Texeurop (BD) Ltd. (10029)

Vogra, Joydebpur, Gazipur
(+ 23.983317N, 90.382354E)

11.MAY.2014

Identified Priority 1 Concerns

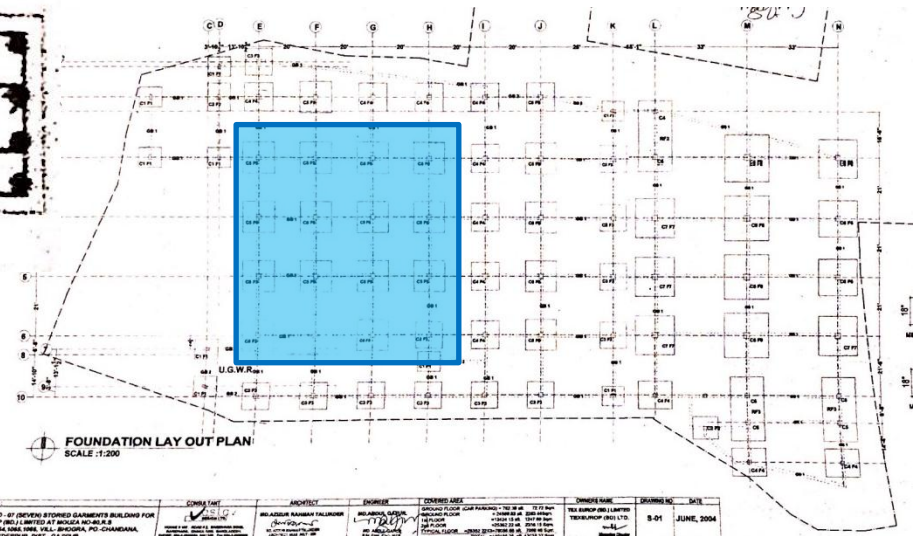
The interior columns, C4 and C5, between grid line E'-I'/2'-6' of Garments Building are supporting the tributary area of 6.30 m x 6.00 m of 8 storeys. The actual condition of column details does not match the details specified in the drawing.

Drawing	On-Site
Size	19"x 19"	18" x 18"
Vertical rebar	12 - φ 25 mm	12 - φ 25 mm
Aggregate	Stone	Brick

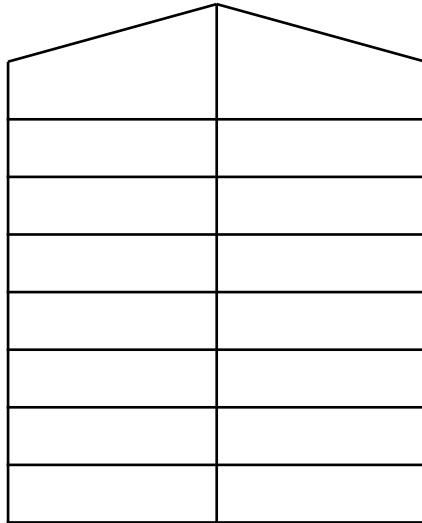
From the result obtained, calculation check of columns between grid line E'-I'/2'-6' appears to be overstressed. Column C4 is indicated that the FoS is **1.14**. And Column C5 is indicated that the FoS is **1.21**.

Remark: Check at ground floor

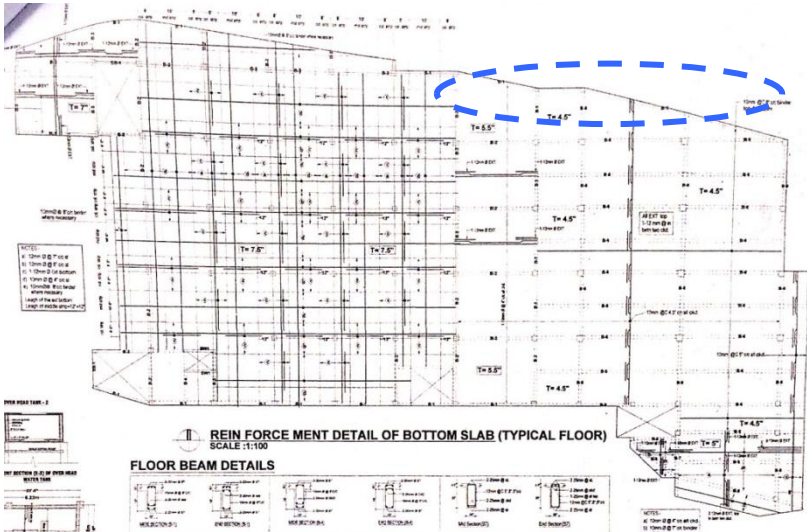
Uncontrolled heavy storage loading was found on the 6th floor supporting by 7.5” thick flat slab without drop panel or column cap. The loading must be reduced to 2.0 kPa to avoid overstress in punching shear, until a DEA is completed for this item.

4	Uncontrolled heavy storage loading on the 6th floor of Garments Building.	Reduce stacking height to ensure total load does not exceed 2 kPa. Factory Engineer to review design, loads, columns stresses and shear stresses in area identified above. Factory Engineer to state the maximum weight that is allowed per square meter. Suggest that state the value on notice boards in this area.	Immediate – Now
5	Uncontrolled heavy storage loading on the 6th floor of Garments Building.	Adopt some sort of signage/staff guidance to ensure that the maximum weight of storage is not exceeded. (Loading Plans).	6-weeks
6	Uncontrolled heavy storage loading on the 6th floor of Garments Building.	Maintain standards of quality control to ensure that storage procedures are correctly followed so that overloading problems do not arise in the future. Implement Loading Plan.	6-months
